North Campus Faculty Housing Phase II  
Project No. FM110407L/986315

**Addendum No. 6**

ADDENDUM NUMBER 6  
to the  
CONSTRUCTION DOCUMENTS

**BUILDING 600B: SECTIONS**

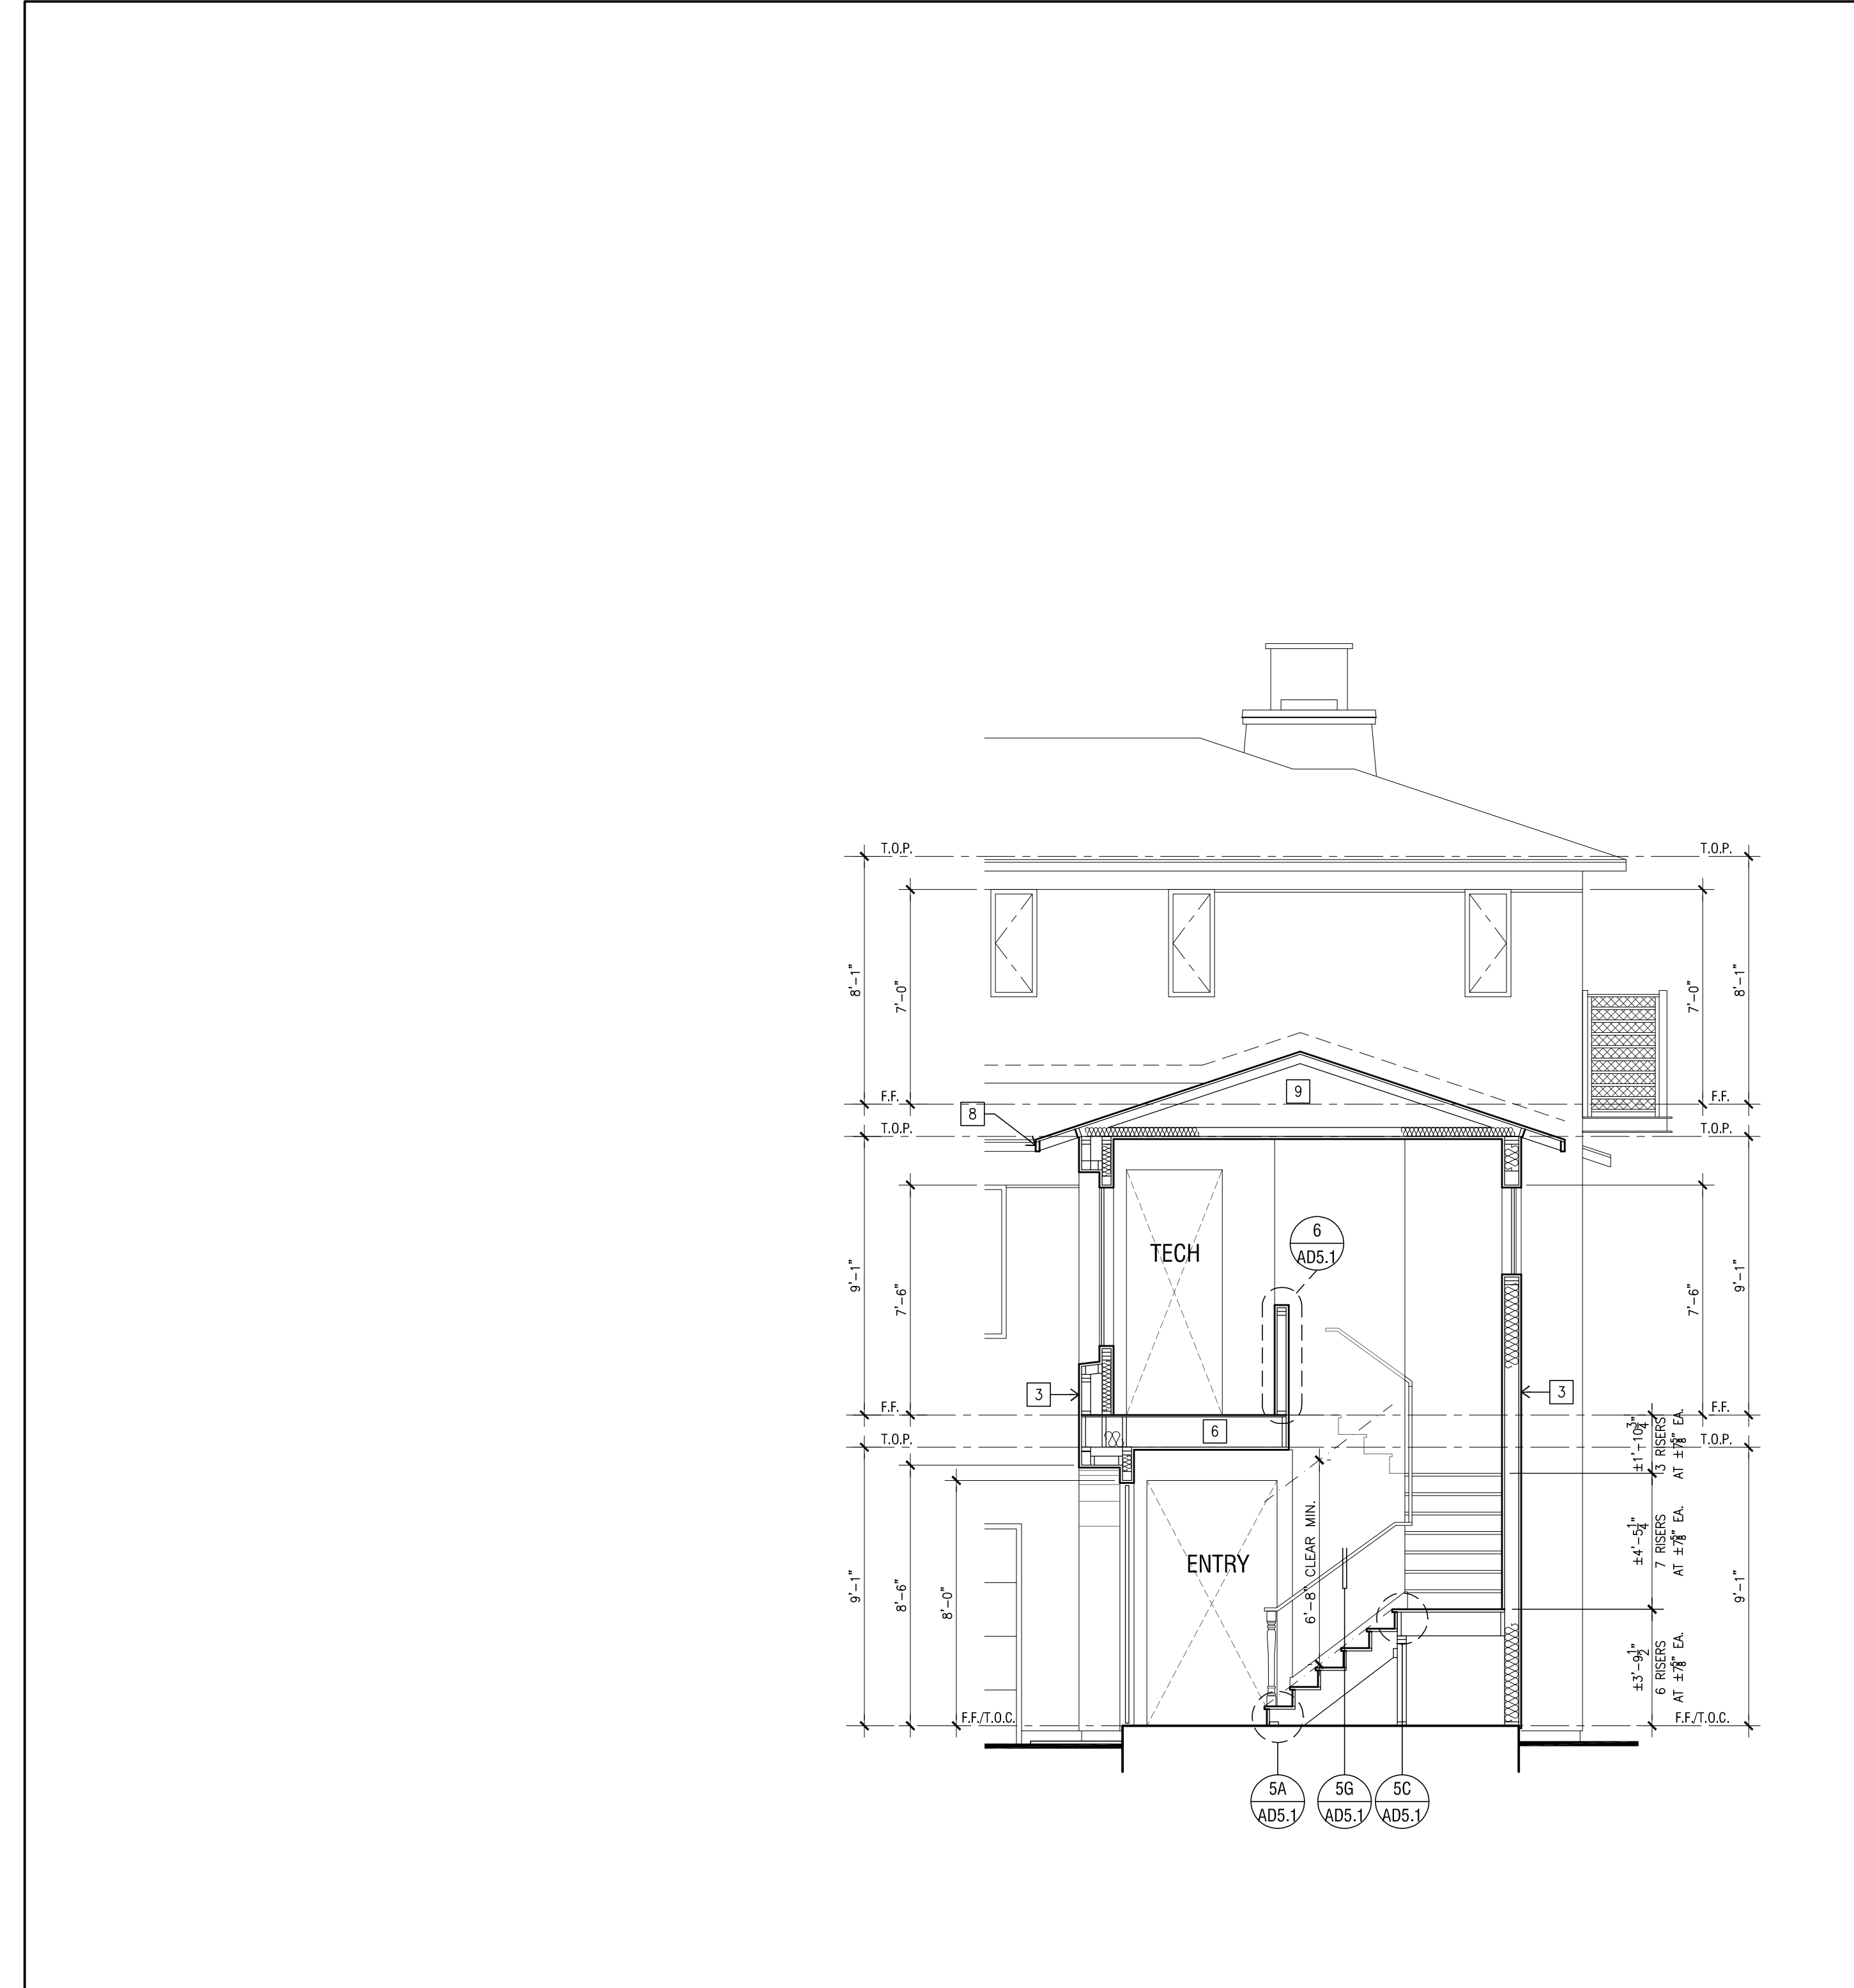
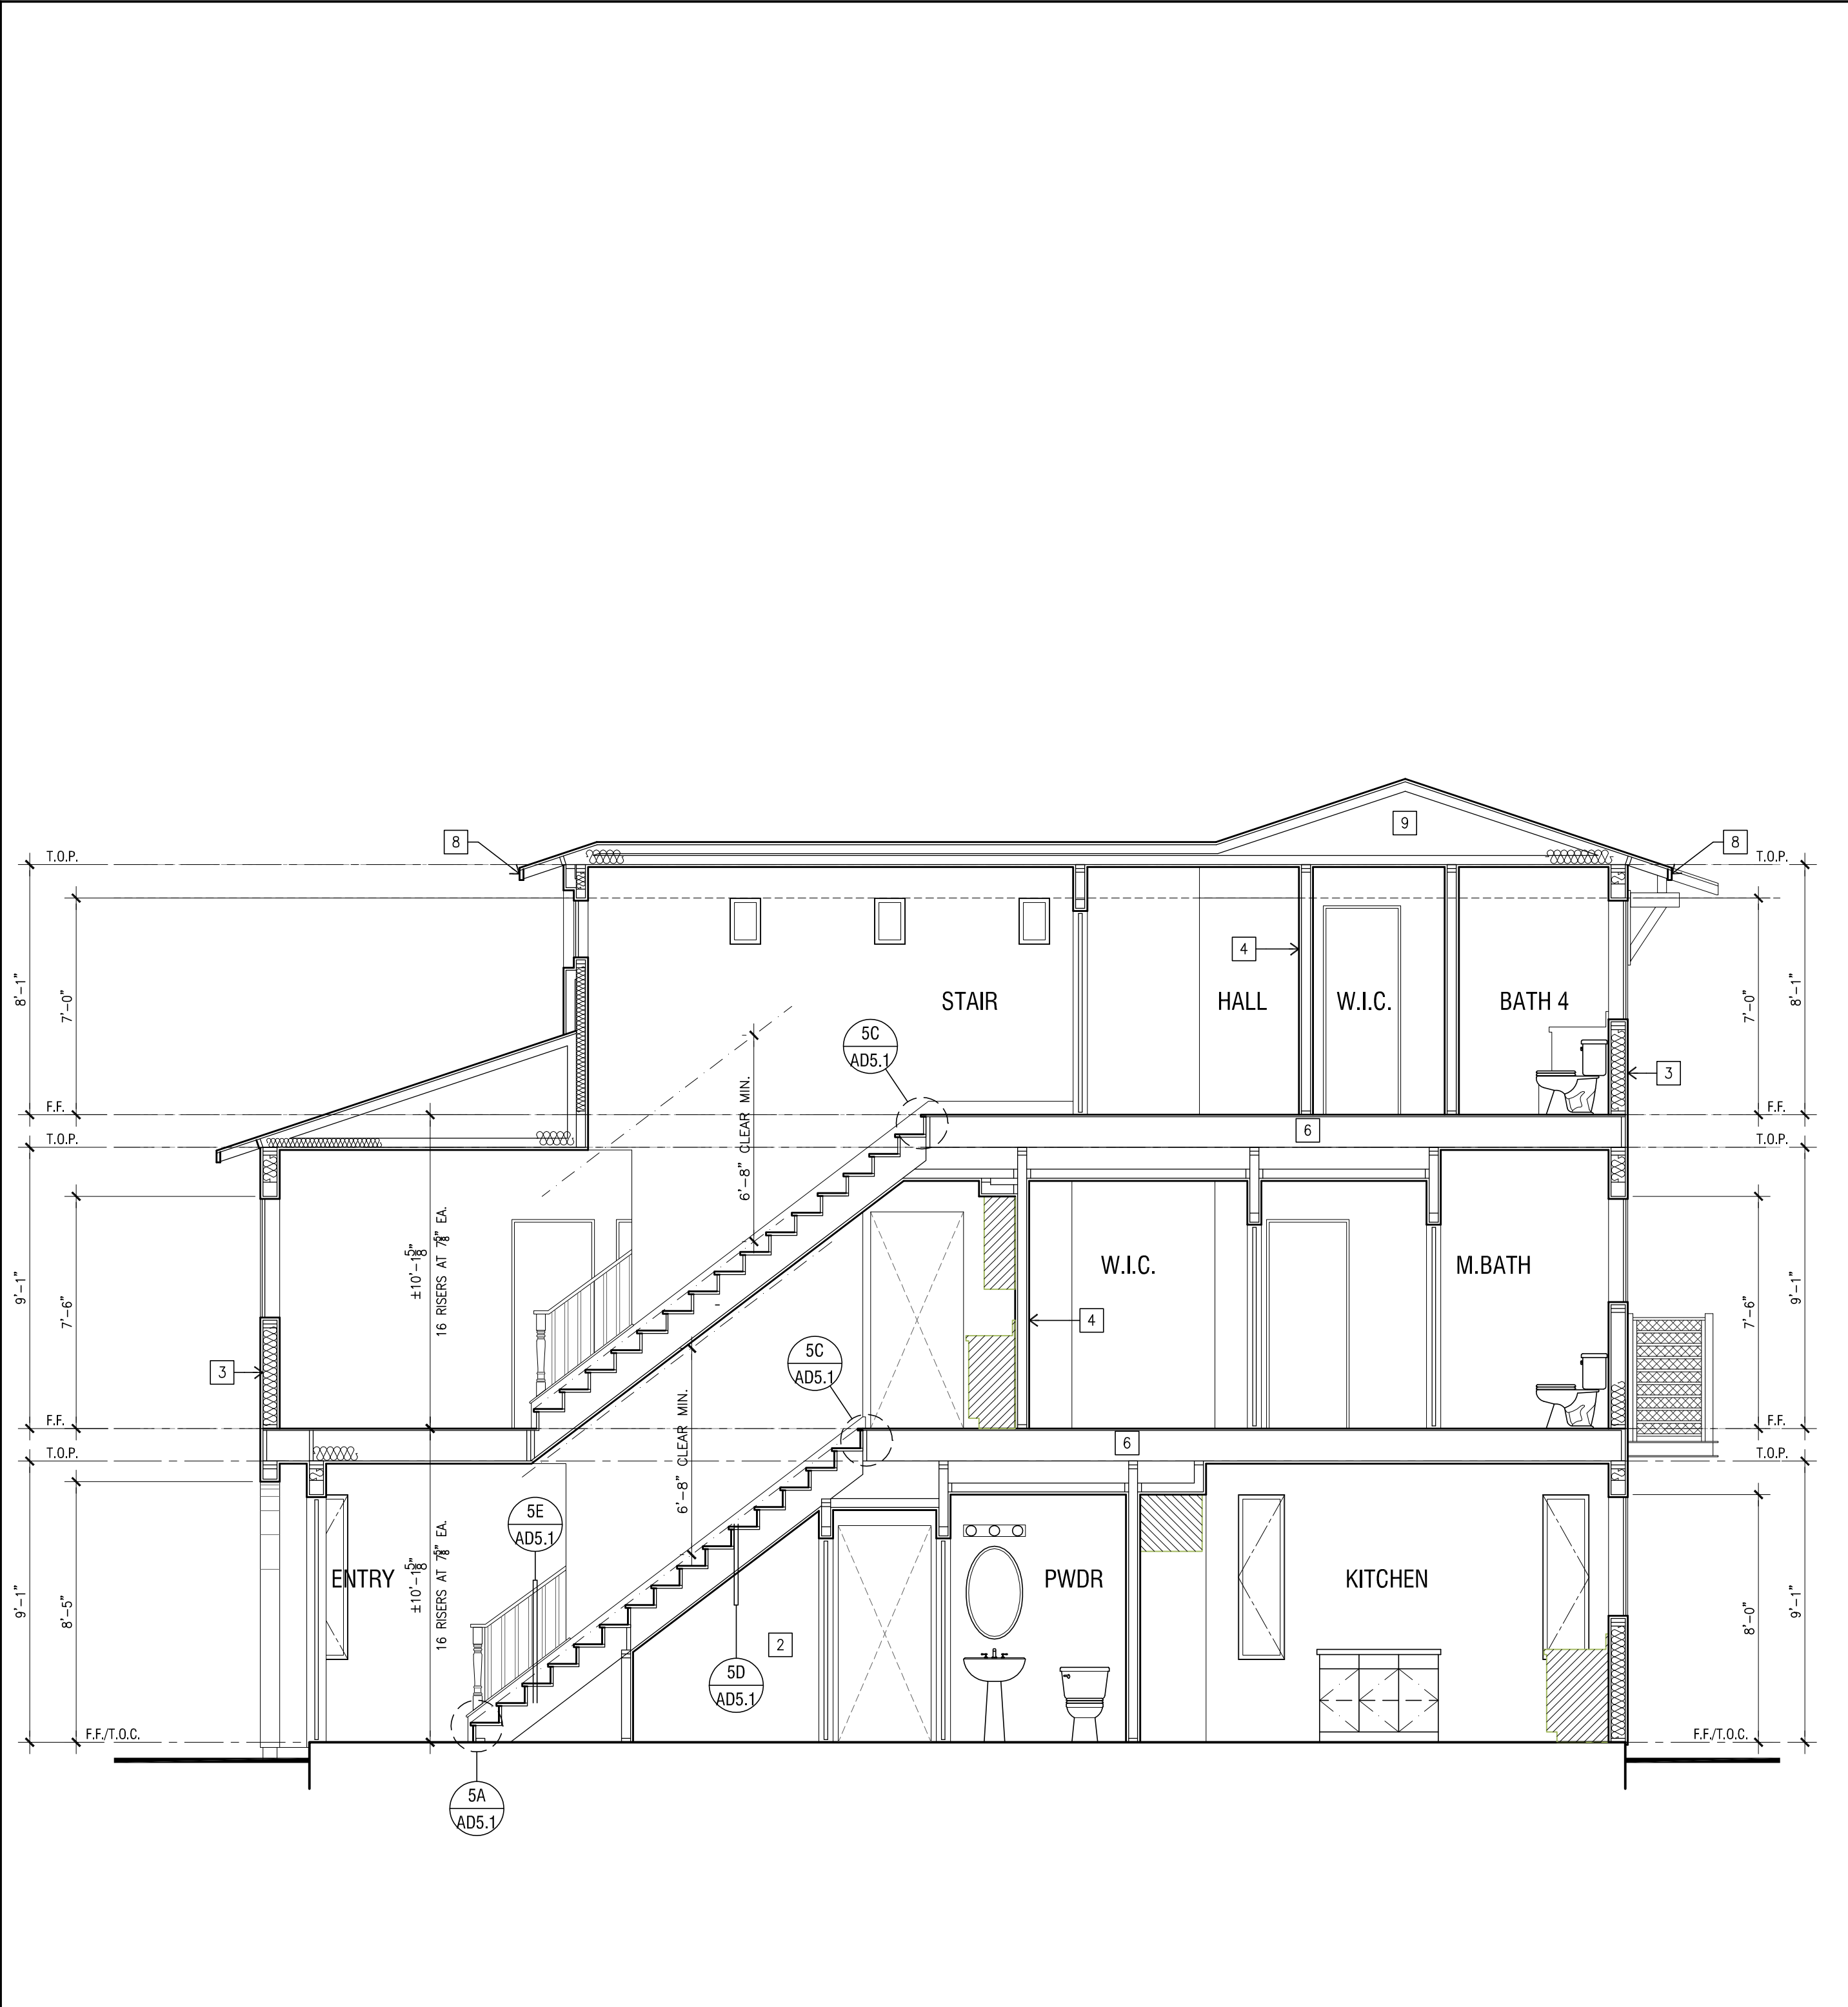
Sketch 5 of 8	Building 600A: Reverse: Sections
Sketch 6 of 8	Building 600B: Sections
Sketch 7 of 8	Building 700A: Sections
Sketch 8 of 8	Building 700A: Reverse: Sections
